Re: Voice of America Park

Enclosed please find one copy the revised detention calculations, storm sewer calculations, and two copies other of the revised site improvement drawings. Changes have been made per your review comments received on May 2, 2012 via email and the following:

STORM WATER MANAGEMENT

VOICE OF AMERICA PARK PHASE 1

**VOICE OF AMERICA PARK
 ATHLETIC COMPLEX**
 SECTION 12, TOWN 3, RANGE 2,
 WEST CHESTER TOWNSHIP,
 BUTLER COUNTY, OHIO
LAKE #3 OUTLET DETAILS (1 of 2)

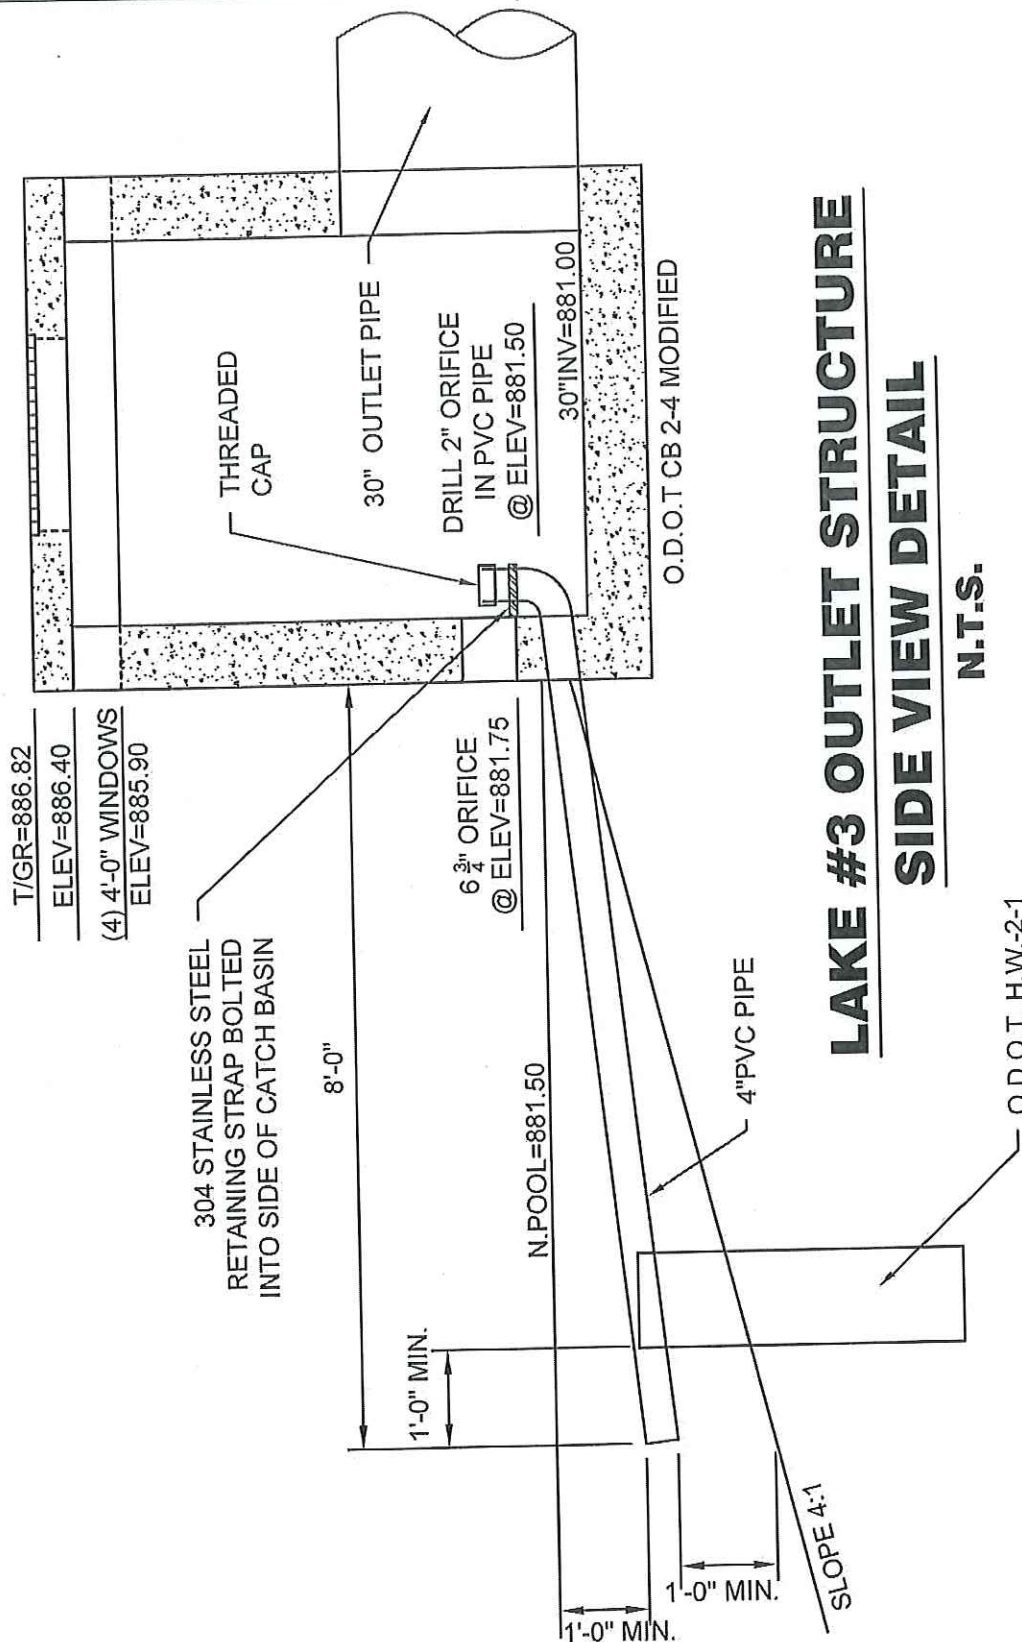
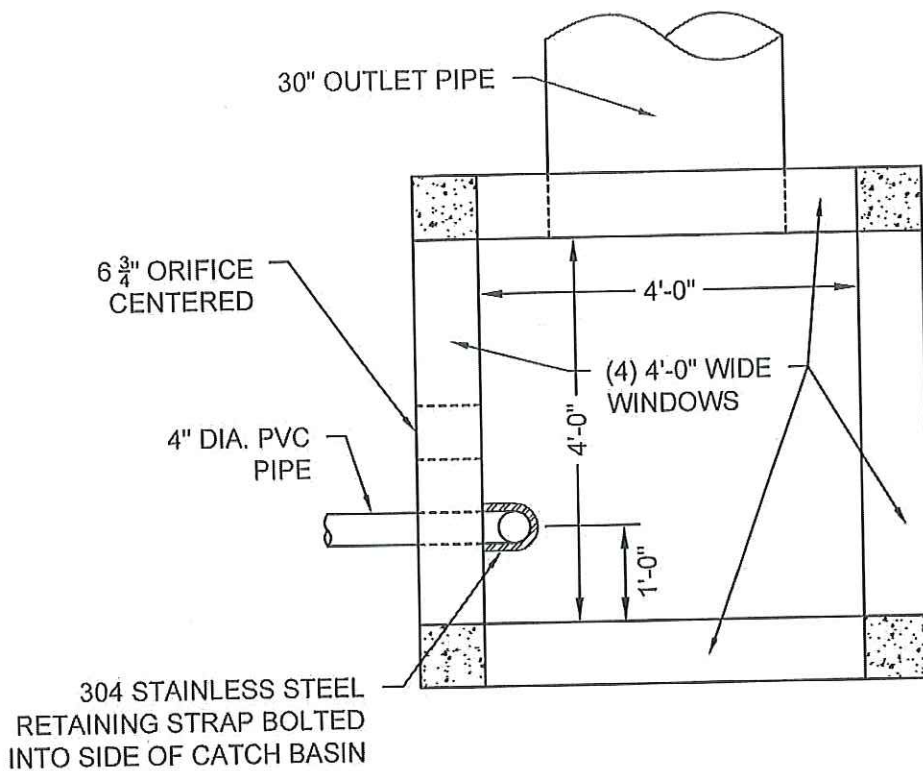
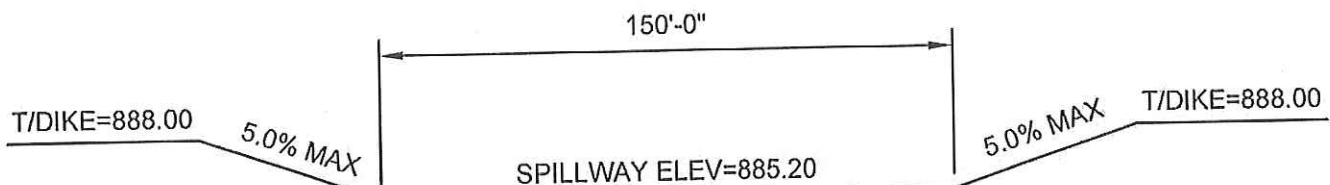
3. The proposed fence to be constructed with Butler Warren Road improvements has been added.
4. In an email sent on February 10, 2012, we asked Steve Hartke to have the path improvement plans changed so that the inverts of the southern 24" pipe would be changed to 886.70 (inlet) and 886.53 (outlet). We will follow up with Steve to make sure that the inverts were changed.
5. Depending on the timing of construction for the park and the proposed path, a couple of storm sewers under the proposed path may not be needed. At this time we do not the construction timing for the park improvements.
6. The spillway for lake #3 has been revised and a proposed ditch has been added to direct to water to the culvert pipe under Butler Warren Road.
7. Outlet for Lake #3 has been revised.
8. The top of grate elevation for Structure 30 (lake #3 outlet structure) has been corrected on all sheets.
